RE: **Lot 24 Block 6 Unit 22 SAD 228
8012 Camino Alderette NW
Volcano Cliffs Subdivision
Grading and Drainage Plan
Engineers Stamp Date 1/21/2022 (D10D003B24)**

Based upon the information provided in your submittal received 2/3/2022, this plan is approved for Grading Permit.

DRAINAGE AND TRANSPORTATION INFORMATION SHEET (REV 6/2018)

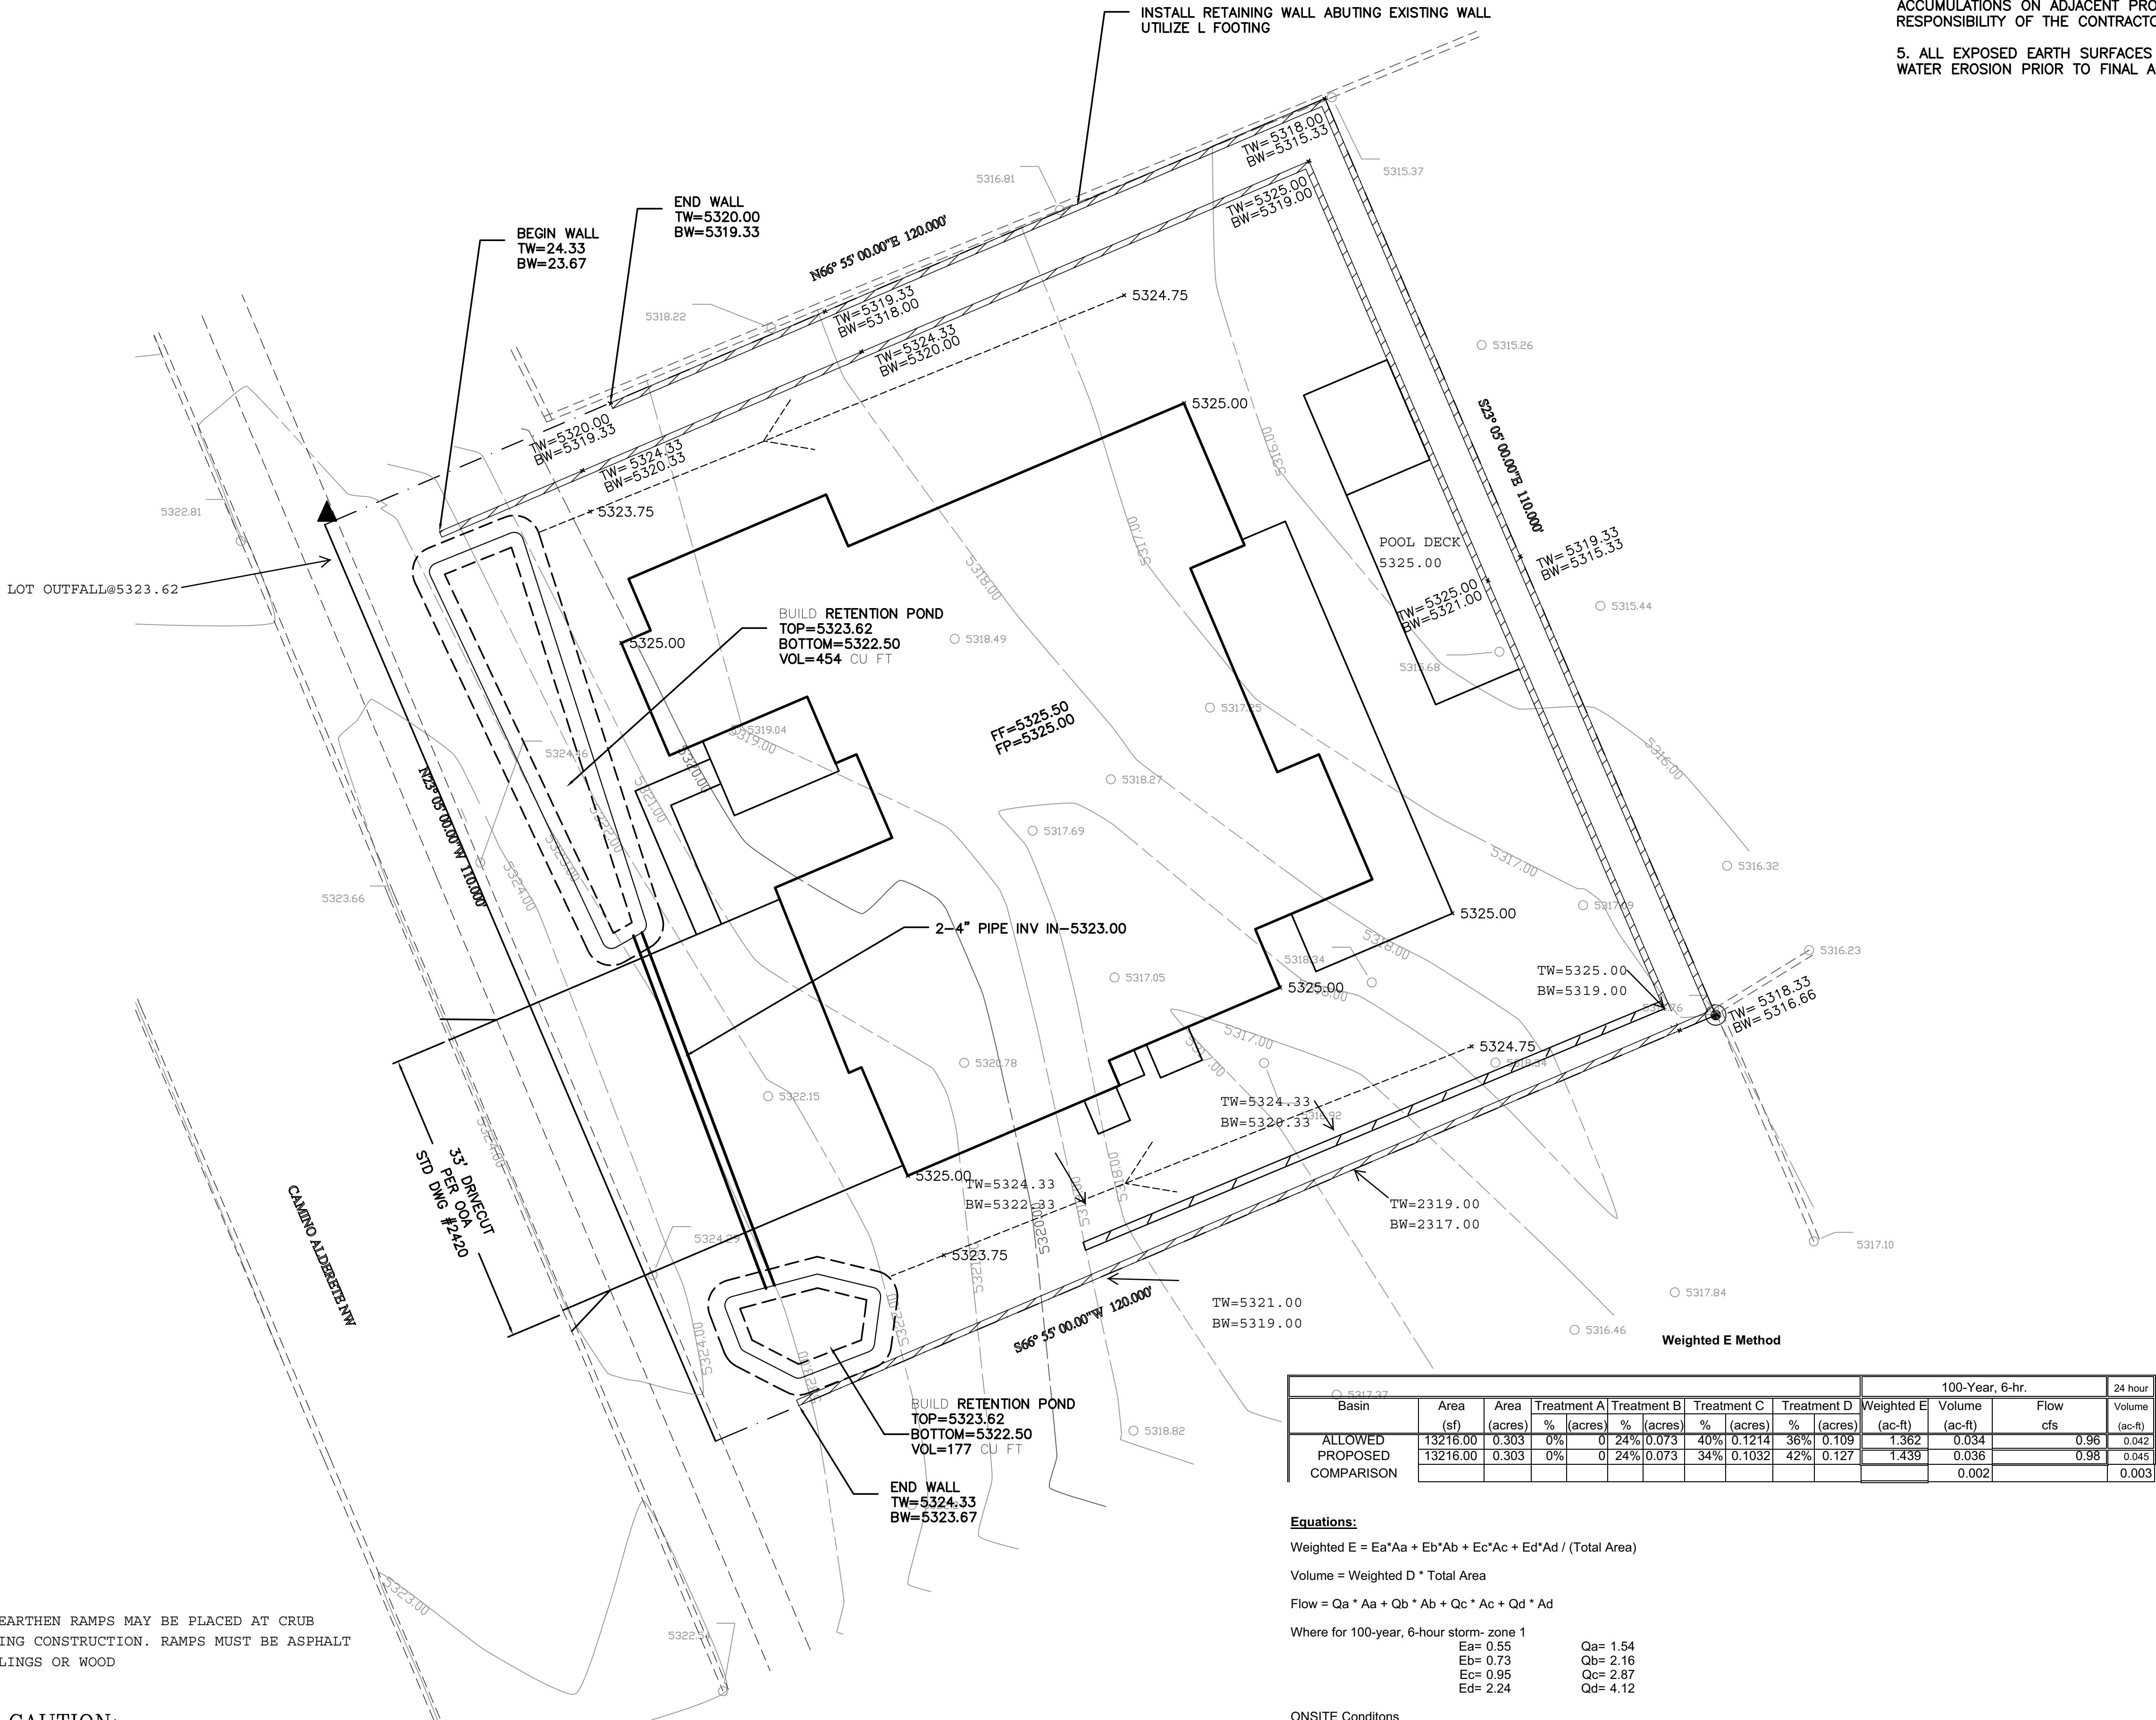
Advise the owner contractor not to use dirt as a ramp to climb the curb, use lumber or crusher fines for this purpose. Place this note on the plan.

NO EARTHEN RAMPS MAY BE PLACED AT CRUB DURING CONSTRUCTION. RAMPS MUST BE ASPHALT MILLINGS OR WOOD
